| DESIGN | | DRAWN BY | DART AEROSPACE LTD HAWKESBURY, ONTARIO, CANADA | |
|----------|------------|------------|---|--------------|
| <i> </i> | <i>?</i> # | 世 | DSI 9369 | SHEET 1 OF 1 |
| 07.02.13 | | | STRUT REPLACEMENT | NTS |

DART SERVICE INSTRUCTION

TO AMEND INSTALLATION INSTRUCTIONS D206-540 Rev. I REF. CANADIAN STC: SH94-5 REF. FAA STC: SR00386NY

D206-540-013 INSTALLATIONS

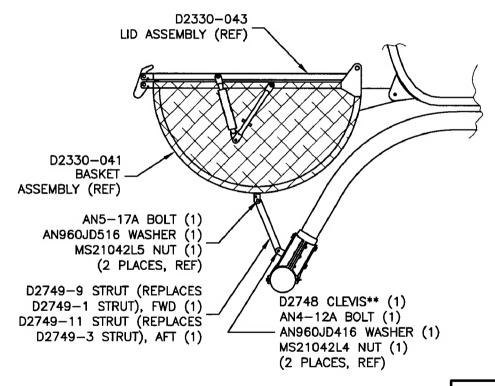
To eliminate interference with the forward hinge of the basket and the door, and to correct the length of the forward strut, it is acceptable to replace the D2749-1/-3 Struts with D2749-9/-11 Struts on some D206-540-013 Heli-Utility-Basket installations as shown below.

REPLACE EXISTING SADDLE WASHER WITH D2748 CLEVIS AND RE-ATTACH USING EXISTING SADDLE HARDWARE.
